<h2>PCN (Product Change Notice)</h2>											
This document applies to all companies and branches of the Würth Elektronik eiSos Group. <input checked="" type="checkbox"/> Major Change <input type="checkbox"/> Minor Change											
PCN Number: PCN_UtPPTI5B_20260211 Affected Series: WE-PPTI Affected Part Number: see table below PCN Date: 2025-11-13 (YYYY-MM-DD) Effective Date: 2026-02-11 (YYYY-MM-DD)	Change Category: <input type="checkbox"/> Equipment/Location <input type="checkbox"/> General Data <input type="checkbox"/> Material <input checked="" type="checkbox"/> Process <input type="checkbox"/> Product Design <input type="checkbox"/> Shipping/Packaging <input type="checkbox"/> Supplier <input type="checkbox"/> Software										
Contact: Product Management Phone: +49 (0) 7942 - 945 5001 Fax: +49 (0) 7942 - 945 5179 E-Mail: pcn.eisos@we-online.com	Datasheet Change: <input type="checkbox"/> Yes <input checked="" type="checkbox"/> No Attachment: <input type="checkbox"/> Yes <input checked="" type="checkbox"/> No										
DESCRIPTION OF CHANGE: <p>Due to an improvement of the production capability, Würth Elektronik will update the wire routing of the below listed parts to enable

Before:

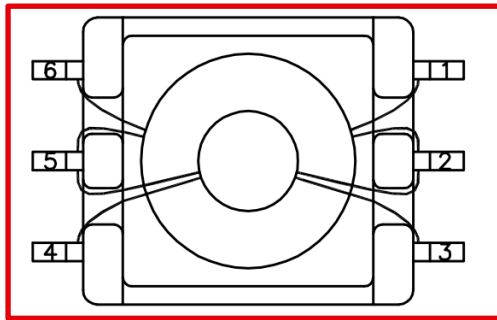
The wire routing will change for all parts listed in the table above. See before change in red and after change in green.
